## **Ealing Development Sites DPD Statement regarding Cycle Parking at Crossrail stations**

### **Draft Arcadia Supplementary Planning Document (SPD)**

*Stepped ramp to lower ground  
secure cycle store, Copenhagen station*

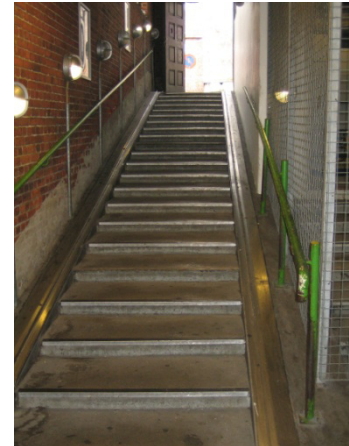
***Possible use of basement voids for cycle parking***

If the railway is decked over, there may well be space at basement level below what is currently the BBC car park, which would be excavated when the foundations are built to support the decking. Such space would have limited commercial use, but could readily be used for secure cycle parking as an addition to the new Bike Hub facilities recently opened by the council. This possibility should be referred to in the SPD.
